# TOWN OF CORTLANDT PLANNING BOARD

**MEETING AGENDA.....PLANNING BOARD  
TOWN OF CORTLANDT  
6:30 THURSDAY EVENING\*  
OCTOBER 7, 2025**

**PB 2023-5** a. Letter dated September 29, 2025 from David Steinmetz, Esq. requesting the 7<sup>th</sup>, 90-day time extension of Final Plat Approval for the Evergreen Subdivision located at 2003 Crompond Road.

STORM PROFILE: HW-MA2

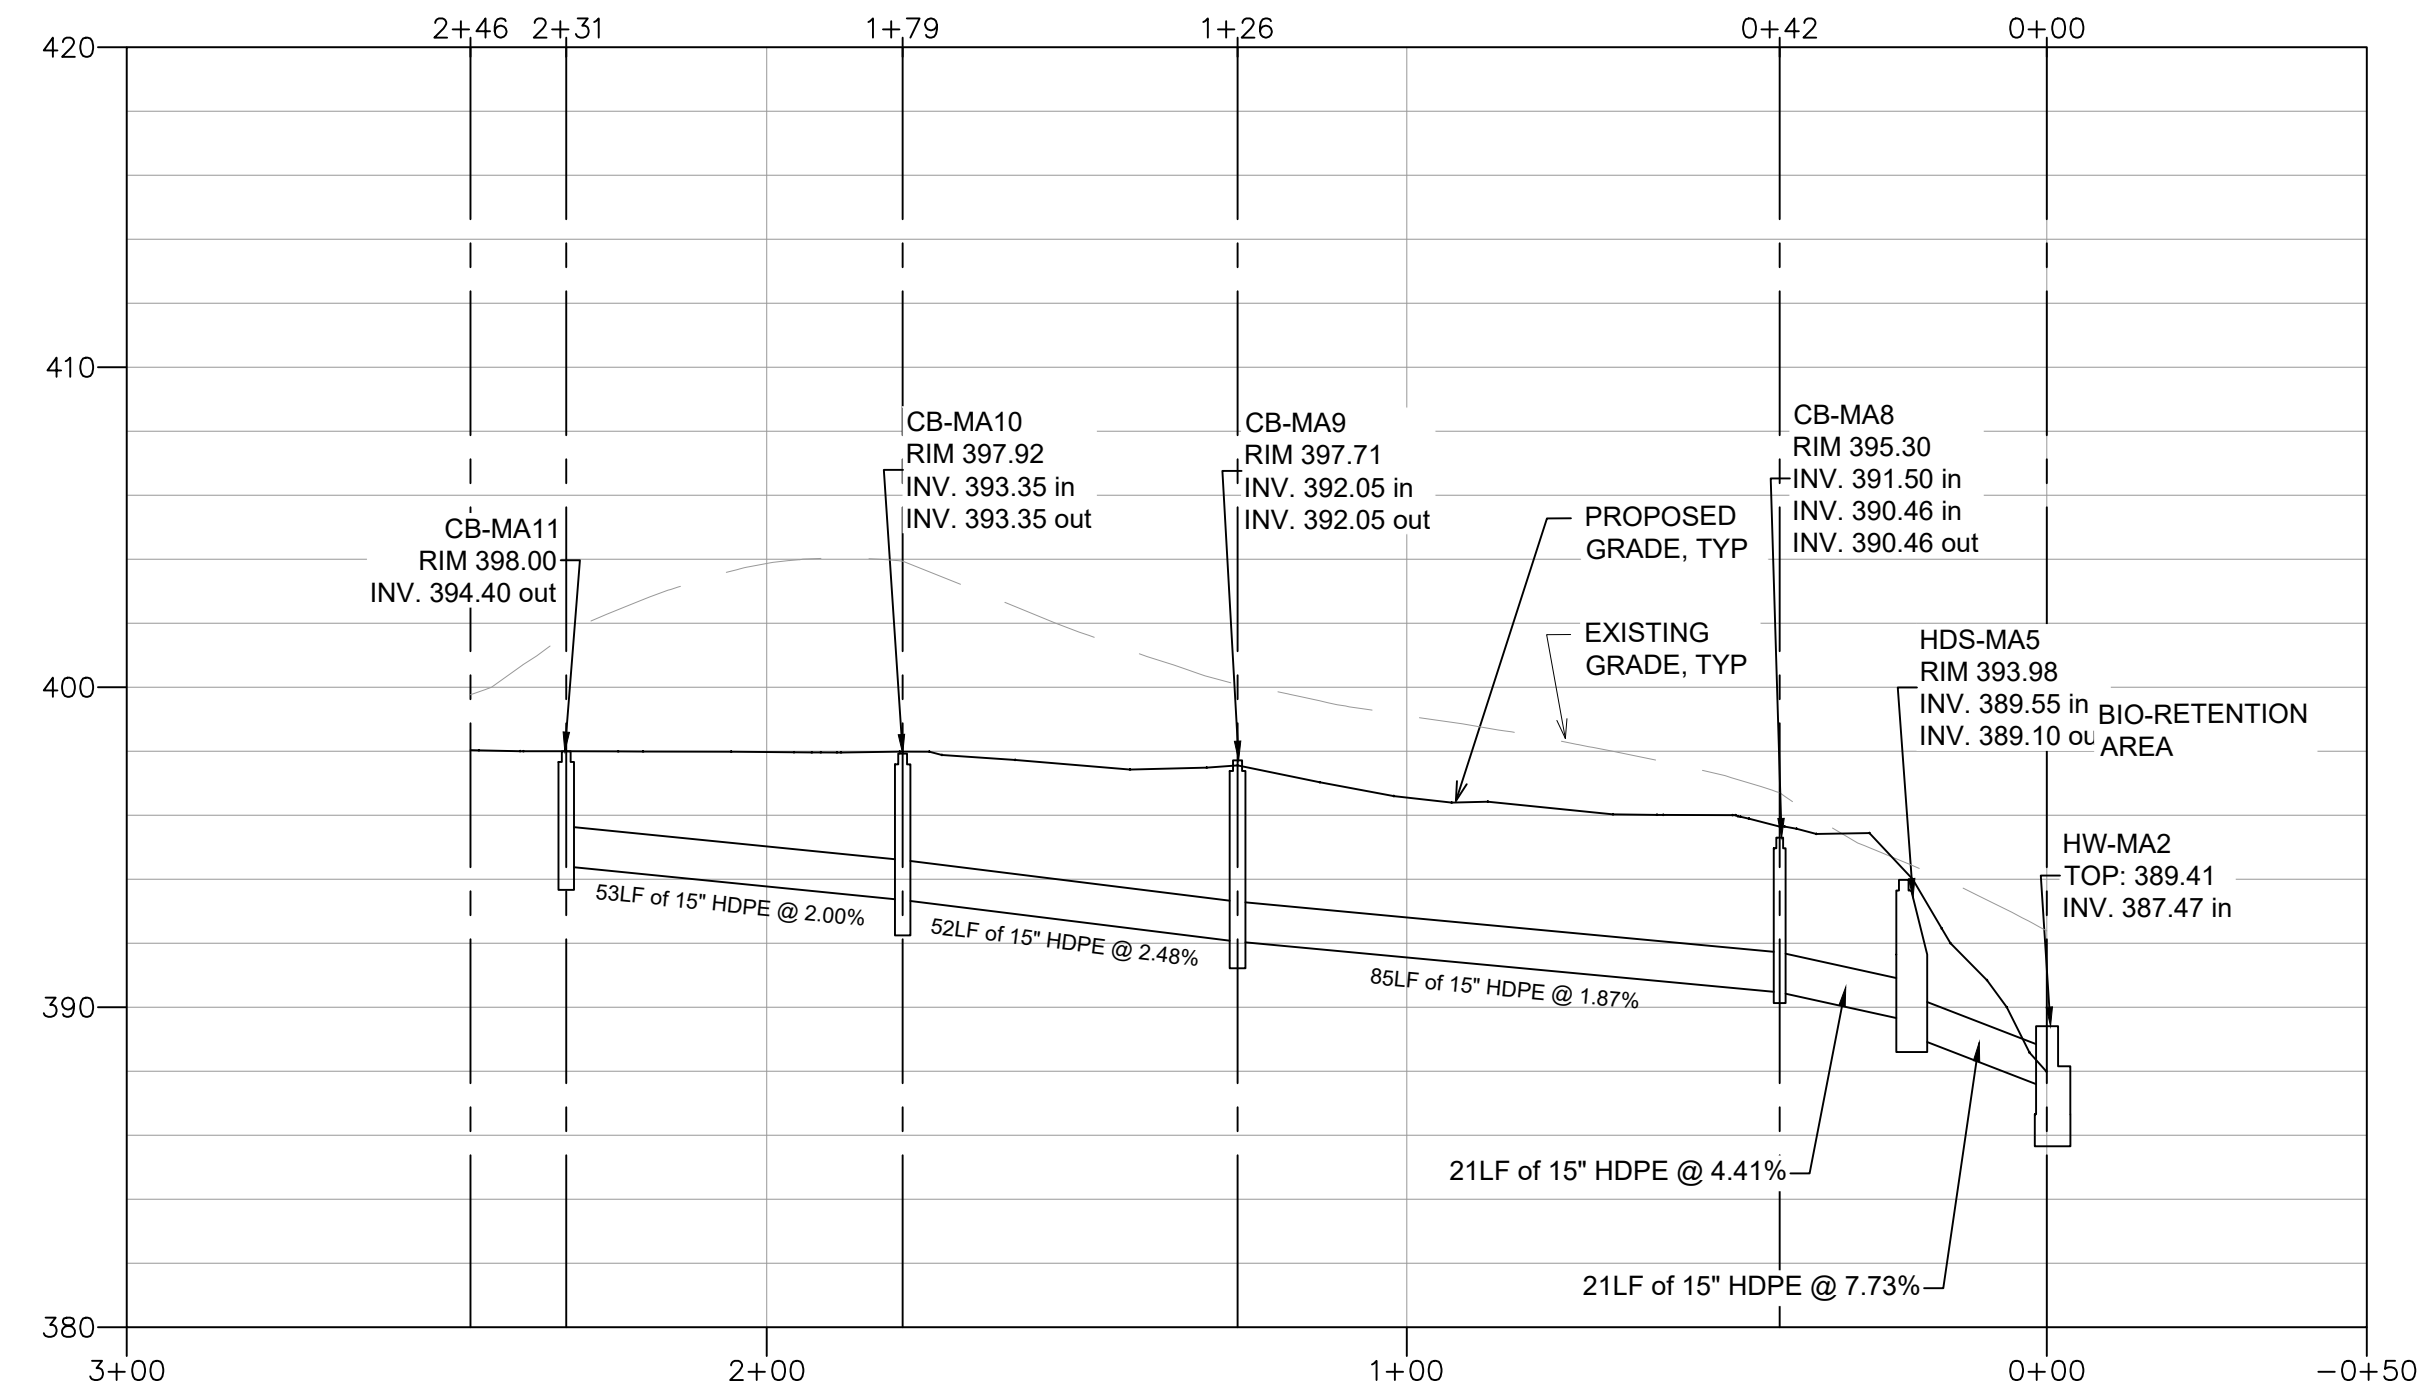
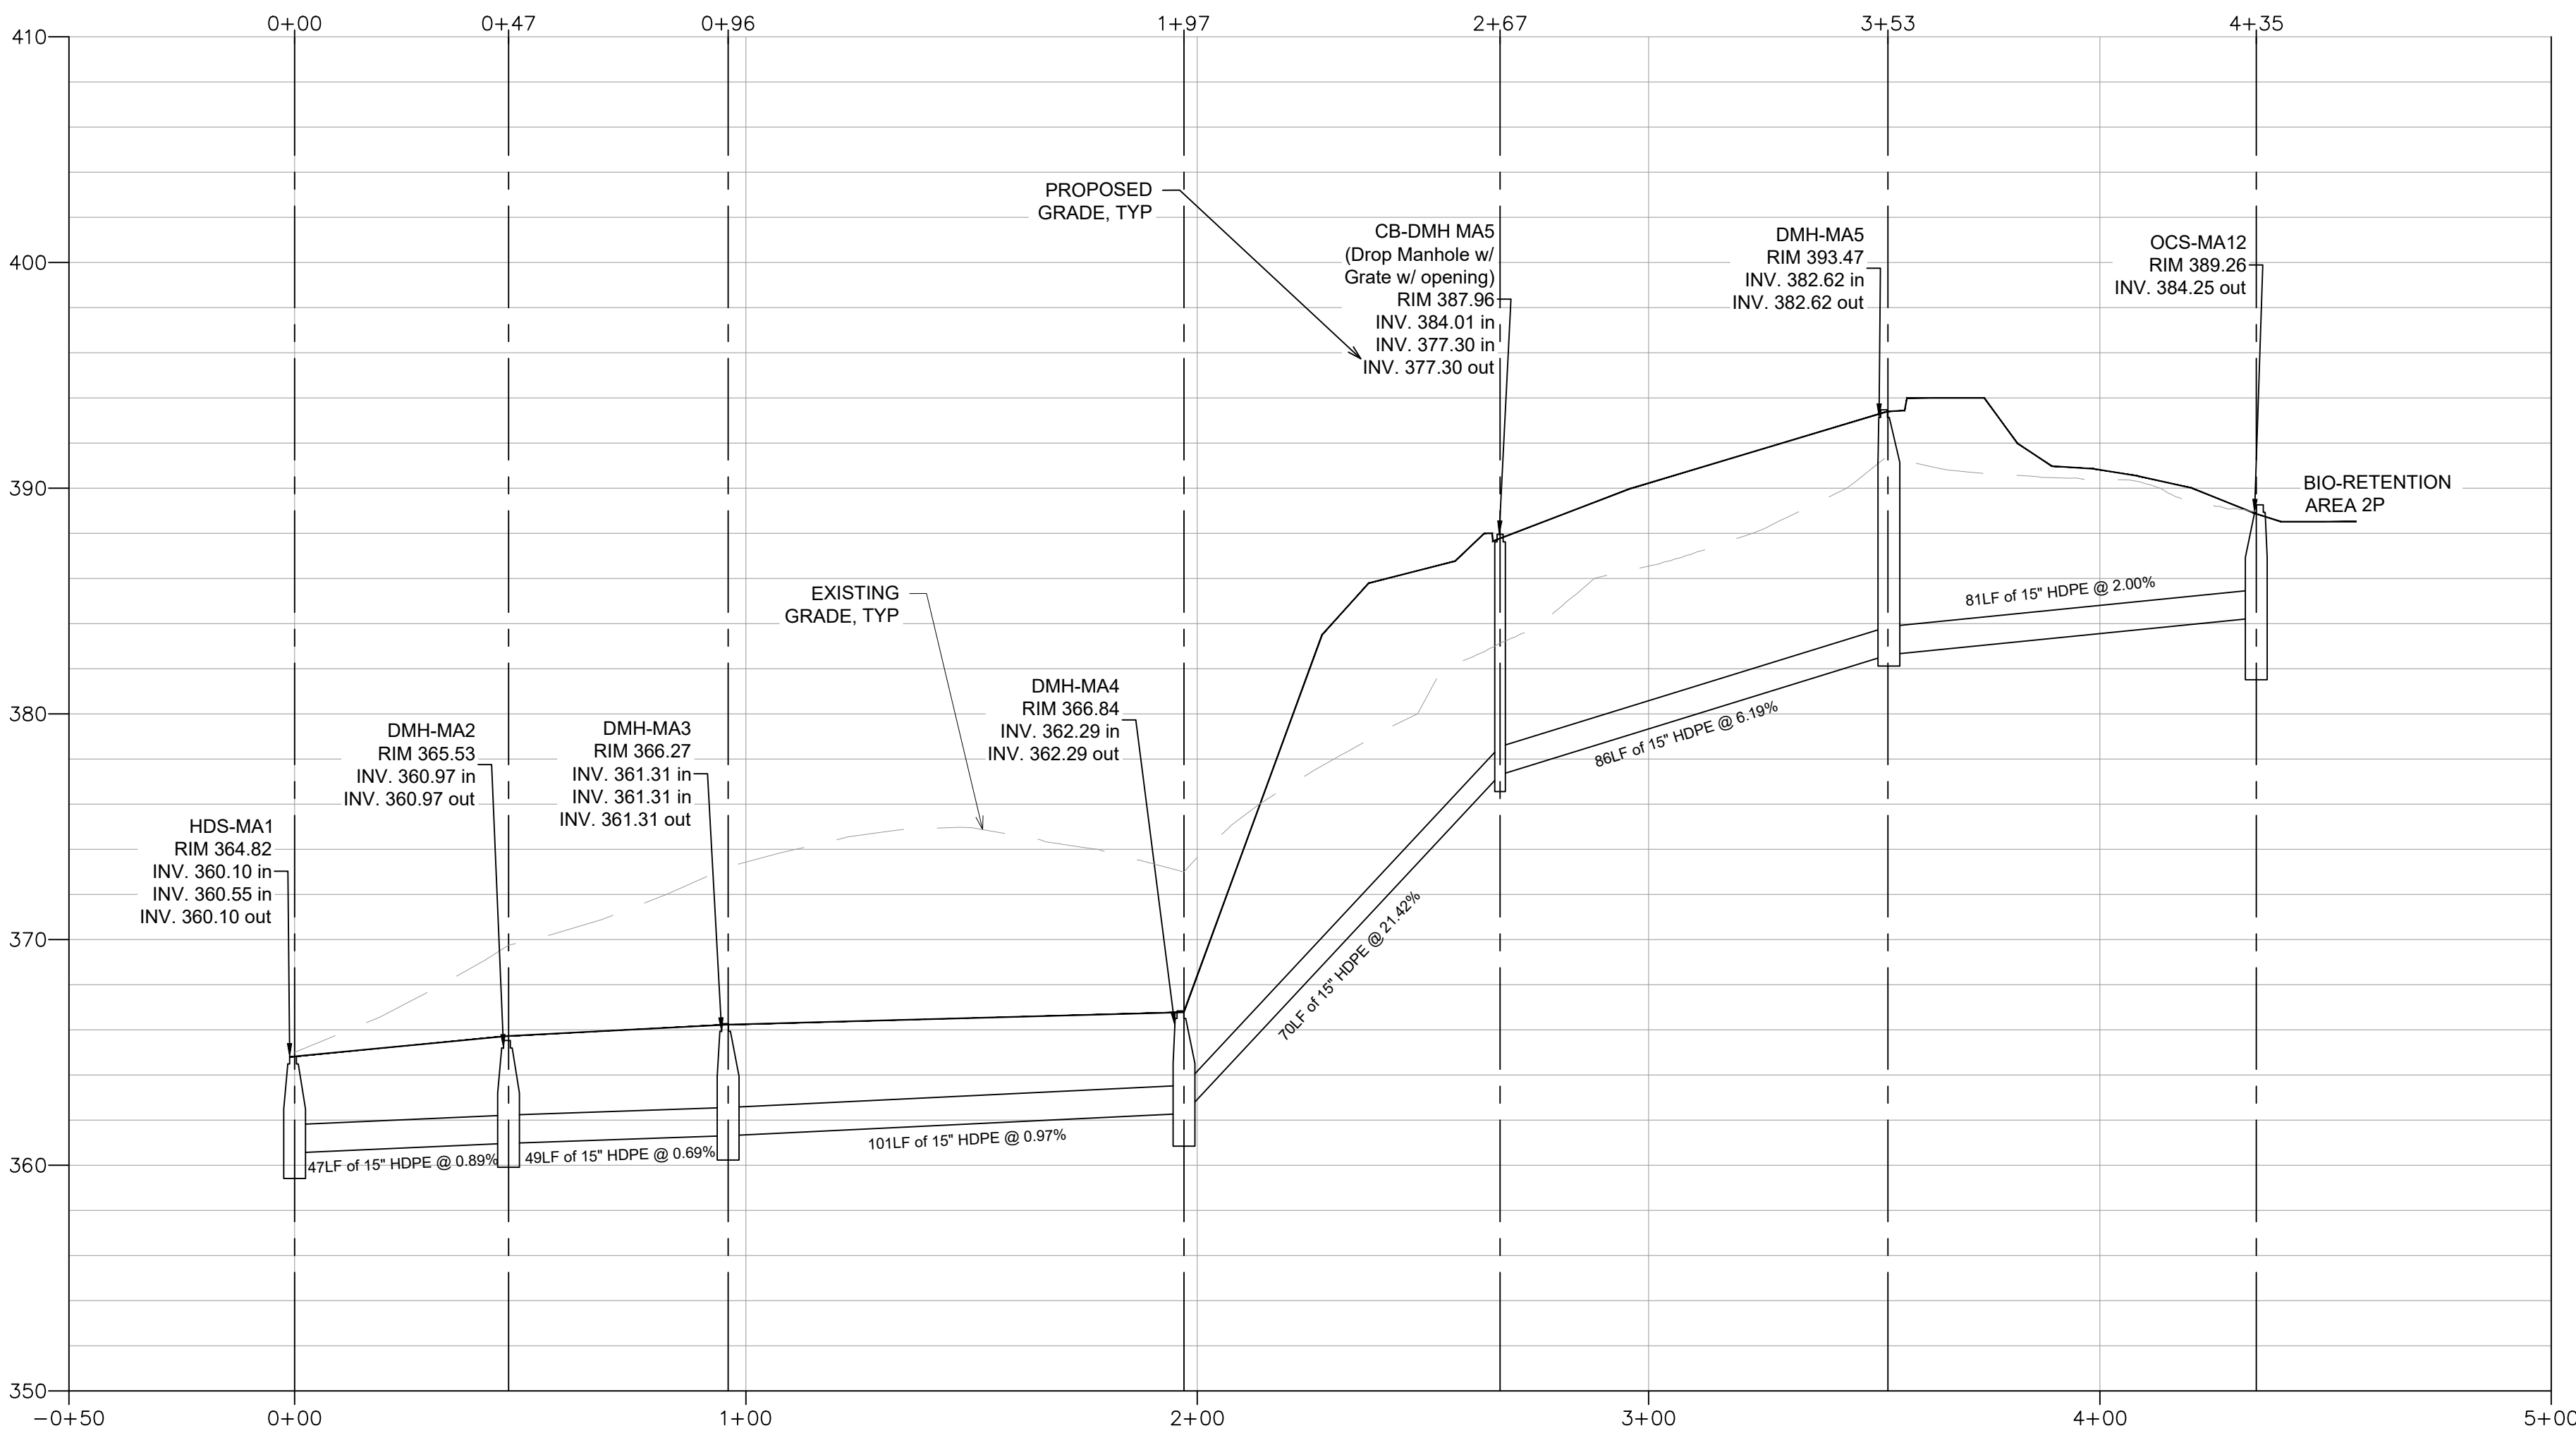
49.     *Comment:*         *SP-3.1 - Provide stationing of all catch basins and drainage manholes.*  
          *Response:*       Stationing of all drainage structures is now shown on the profiles.

50.     *Comment:*         *SP-3.1- Provide stationing and invert elevations of all crossings.*  
          *Response:*       Stationing and invert elevations of all crossings are now shown on the  
profiles.

51.     *Comment:*         *SP-3.1 – Provide a slope for the concrete pipe at the end of profile HW-MA1*  
          *Response:*       The pipe slope has been added.

52.     *Comment:*         *SP-3.1 – Provide anti seep collars on the pipe between CB-MA5 and DMH-*  
                              *MA4*  
          *Response:*       A concrete anti-seep collar detail has been added to Drawing SP-4.1.

53.     **Comment:**     *SP-3.1 – The invert out of CB-MA5 is higher than the lowest inv. in.*  
          **Response:**    The invert out has been revised as required.

54.     **Comment:**     *SP-3.1 – The profile shows downstream pipe sizes smaller than upstream pipes. This design is not acceptable and should be revised.*

55.     **Comment:**     *SP-3.1 – CB-MA8 is shown to have two outlets. One is higher than the invert into this structure.*  
          **Response:**    The outlet configuration at CB-MA8 has been revised. The structure now shows a single outlet at the correct invert elevation, consistent with the incoming pipe. The profiles and drainage schedules have been updated accordingly.

56.     **Comment:**     *SP-3.1 – The bioretention areas should be designed offline with an upstream bypass to prevent excessive flows from entering the practice.*

SP-4.5

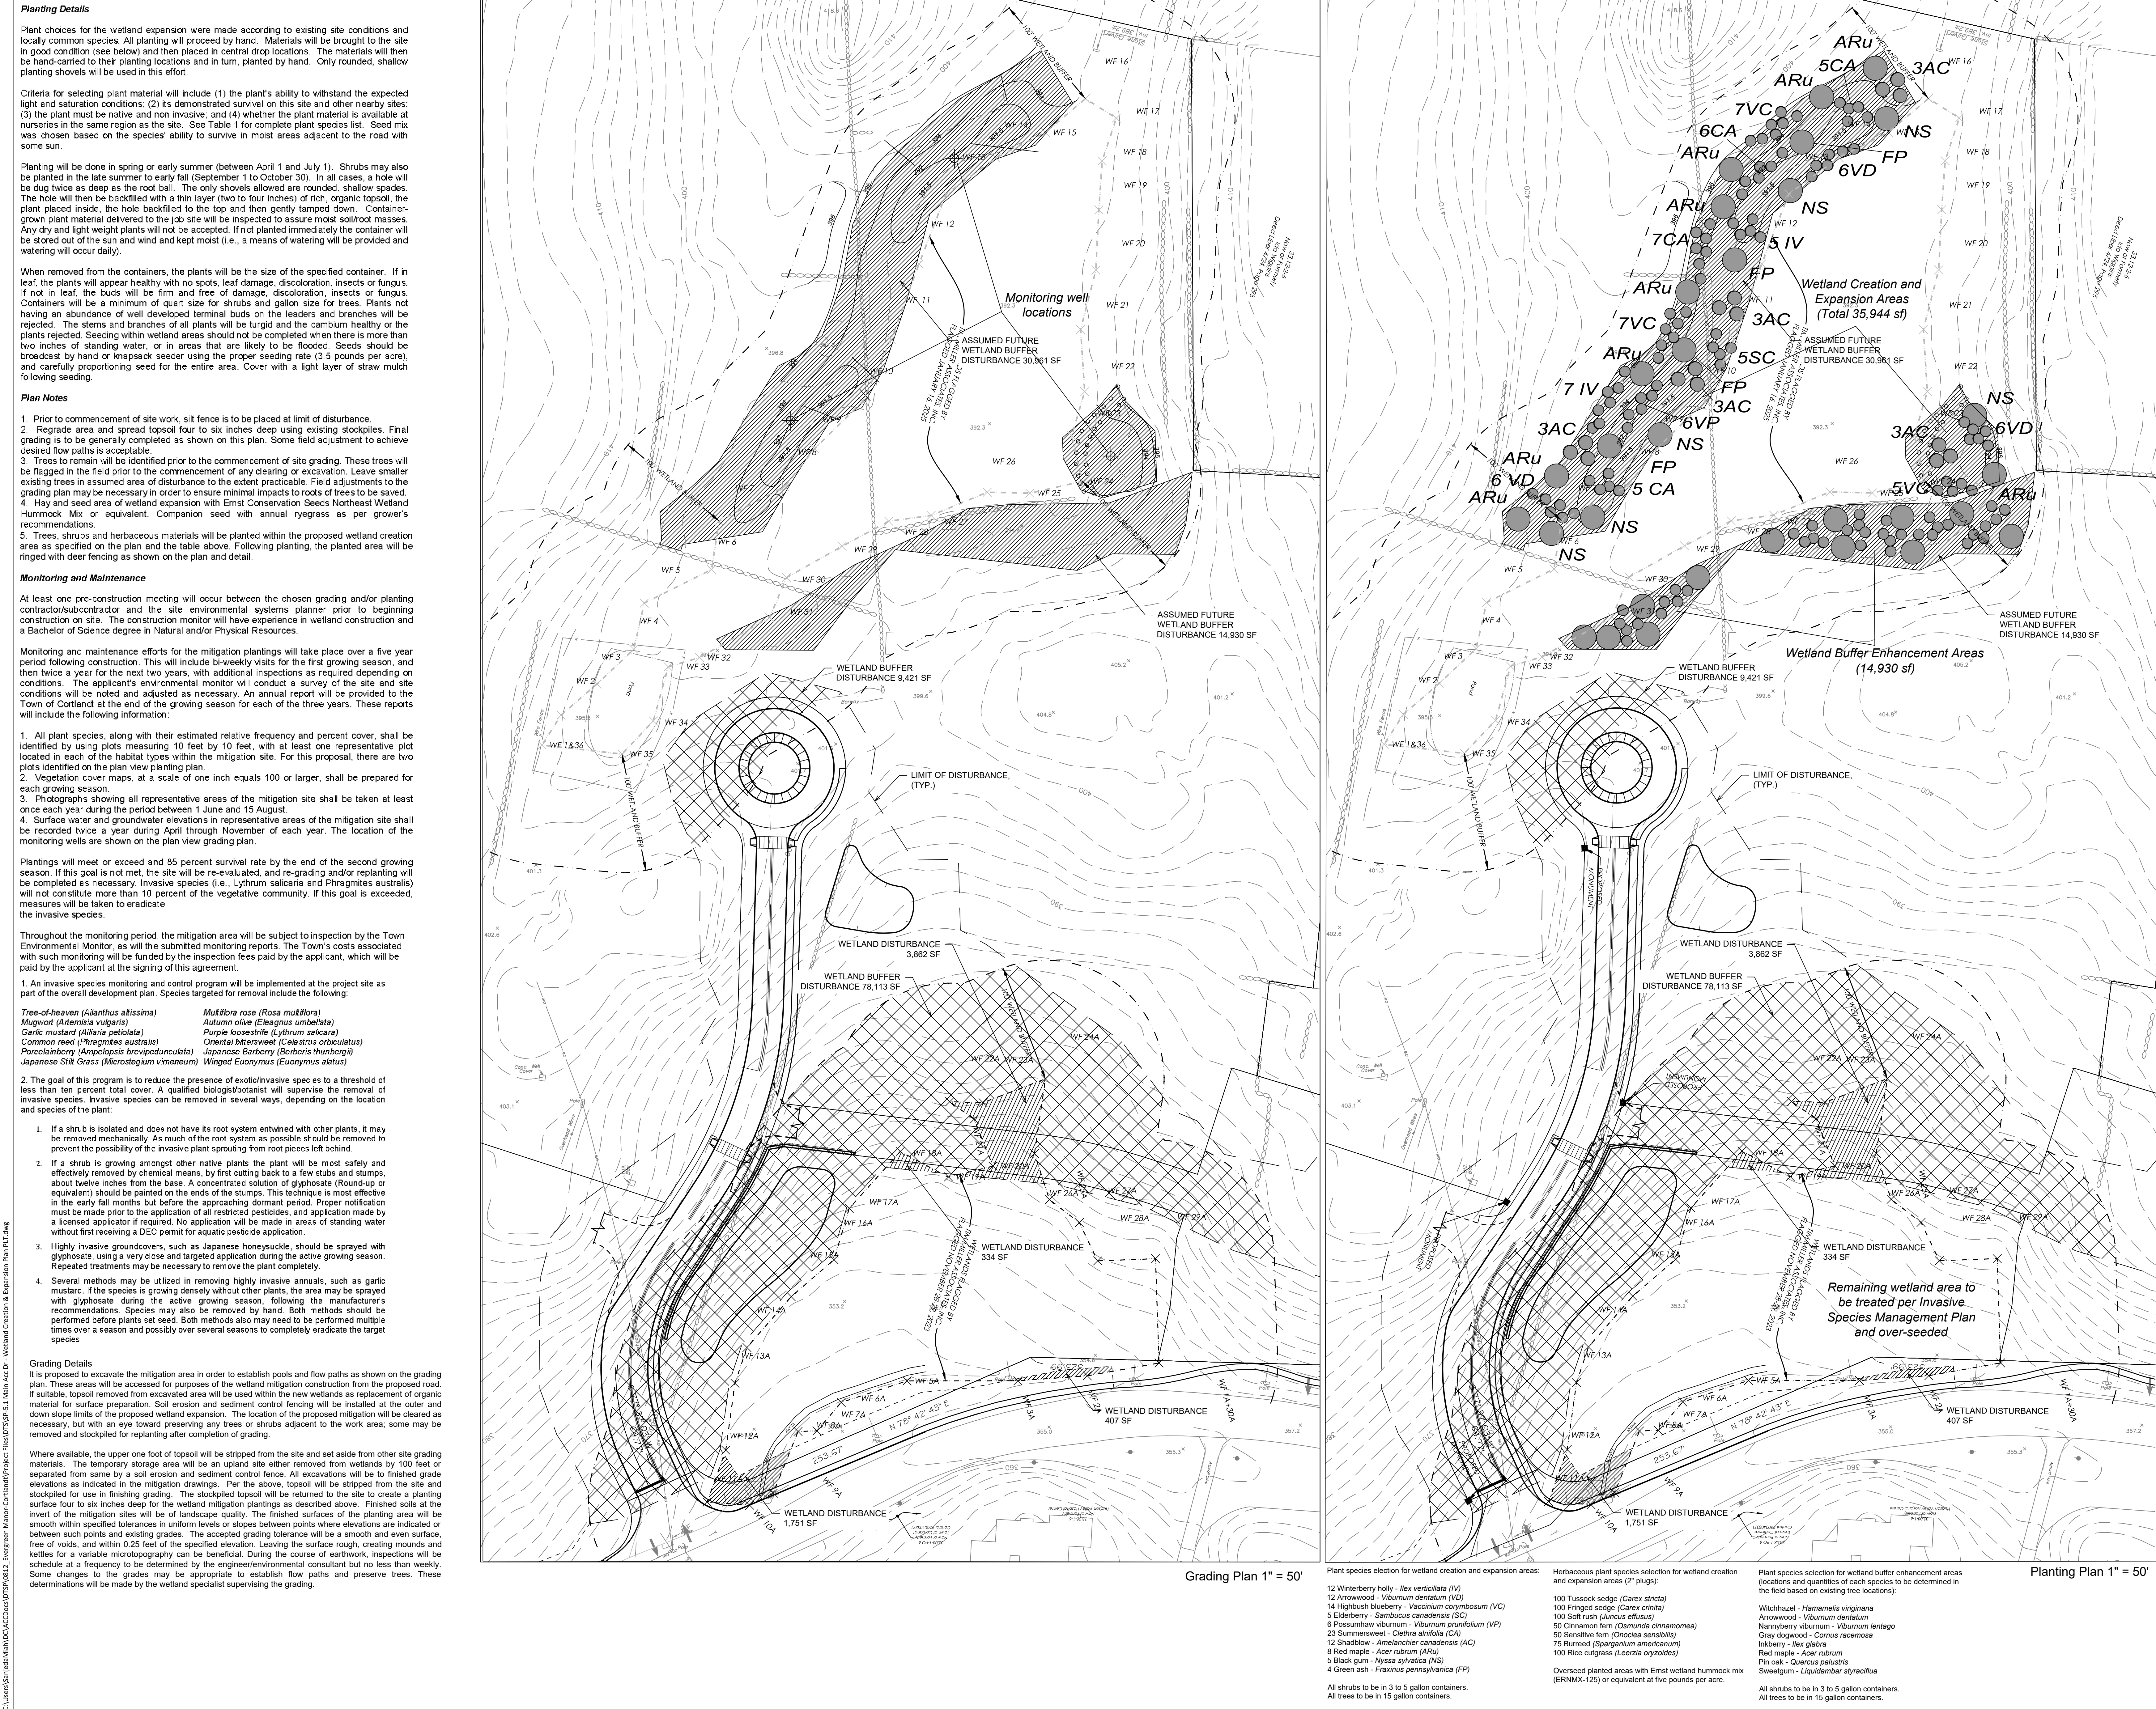
79. **Comment:** *SP-4.4 - Add a note to the retaining wall plan indicating that the wall drain shall not discharge to any stormwater treatment practice.*

81. **Comment:** *SP-4.4 - Add note to the plan indicating contractor shall submit a building permit for the construction of the retaining wall.*

82.     *Comment:*        *SP-4.4 – Add a note indicating, the Town will require certification from a licensed NYS Engineer indicating the retaining wall was constructed in accordance with the engineering design plans and reports.*  
          *Response:*      A note has been added to retaining wall Drawing No. SP-4.5.

**Response:** A note has been added to retaining wall Drawing No. SP-4.5.

**Response:** A note has been added to retaining wall Drawing No. SP-4.5.
